33 CFR Parts 155 and 157

46 CFR Part 162

Pollution Prevention Equipment

ACTION: Interim rule; request for comments.

FIGURE 162.050–17(d)—SAMPLE POINT

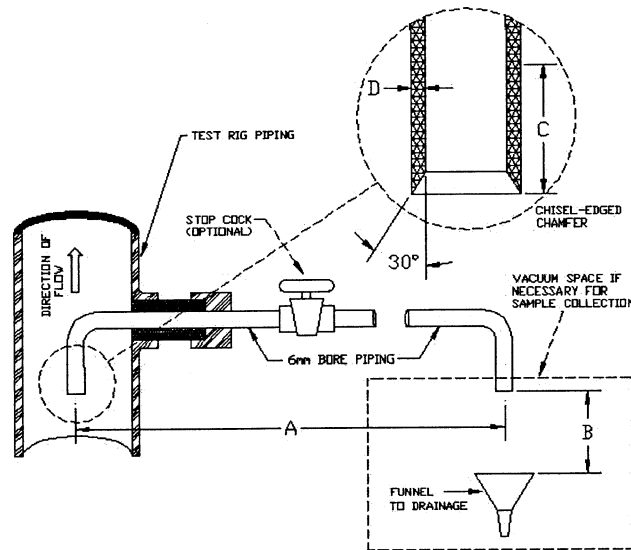
Issue 57: One commenter stated that the 30° chisel-edged chamfer in figure 162.050–17(d), Sample Point, should be around the outside perimeter instead of the inside perimeter of the sampler inlet to minimize disturbance of the sampling flow and to be consistent with MEPC.107(49).

Response: We agree and have corrected the chamfer illustrated in Figure 162.050–17(d).

FIGURE 162.050-19—MONITOR AND BILGE ALARM TEST RIG

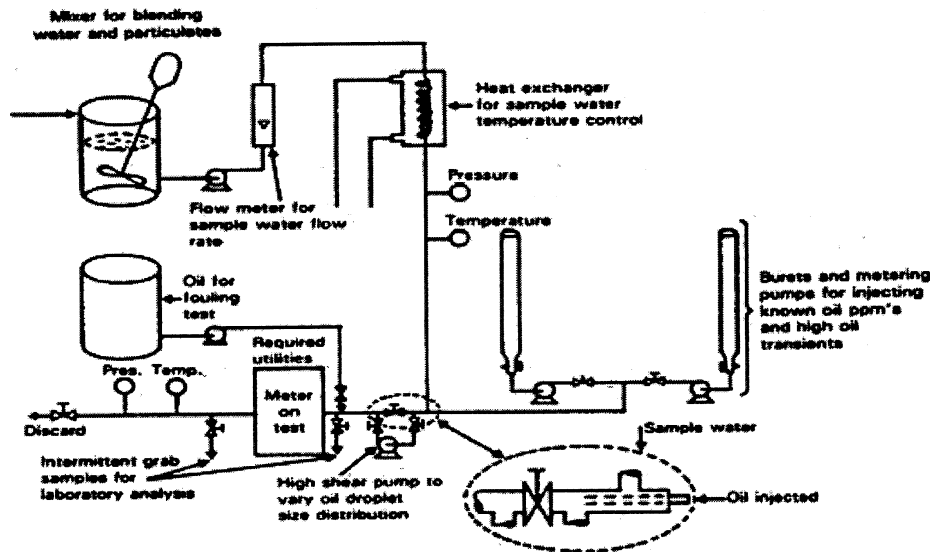
Response: The Coast Guard disagrees. Our figure at 46 CFR 162.050–19 and MEPC.107(49) figure 5 stipulate “burets and metering pumps for injecting known oil ppm's and high oil transients,” and thus provide discretion

to the testing lab to deliver the oil in the manner of its choosing. During the review of a facility's application under 46 CFR 162.050–15, we examine information on the facility's test rigs. Any deviation from the required test rigs must be noted in this information. We have no evidence of buret injections creating pulsations of oil injections at low concentrations. We made no changes in response to this comment.

Figure 3 - Tank of Test Fluid "C"

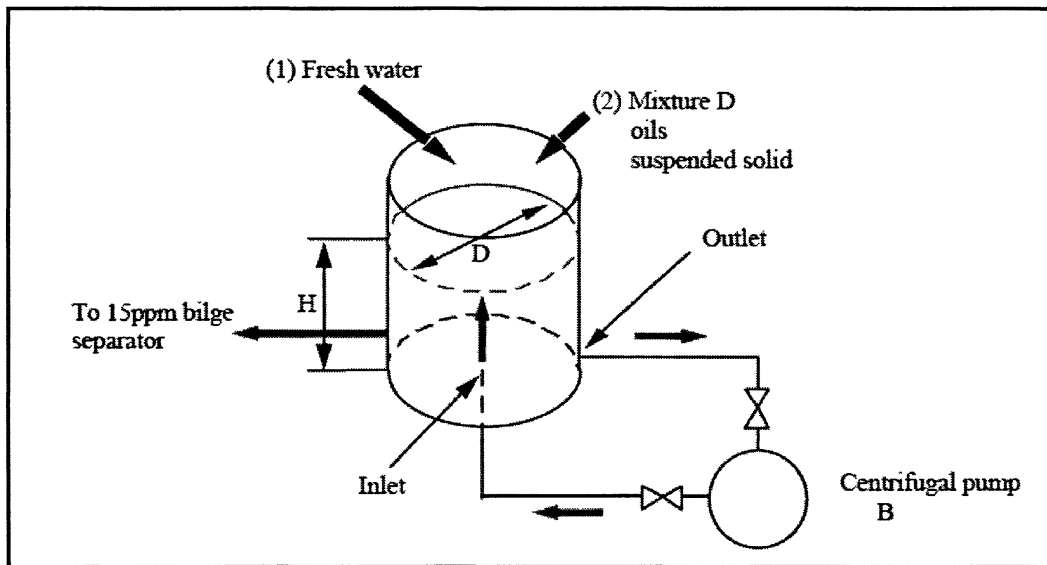
Issue 60: One commenter suggested including the specifications of the tank used for Test Fluid C per Figure 3 and notes 1 through 3 of paragraph 1.2.4 of Part I of the Annex to MEPC.107(49) as it would ensure consistent mixing of Test Fluid C by different test facilities.

Response: The Coast Guard agrees. Our proposed paragraph (b)(2) of 46 CFR 162.050–20 references a worksheet, figure 162.050–20, for determining Constituents of Test Fluid C. In response to this commenter's suggestion, we are adding MEPC's Figure 3 to that worksheet, and have inserted the notes as text in that worksheet.

(2) Outlet going to centrifugal pump B should be placed at as low a position to the tank as possible.

(3) Inlet to the tank should be fitted at the center of tank bottom so that the mixture flows upward to obtain uniform and stable emulsion.
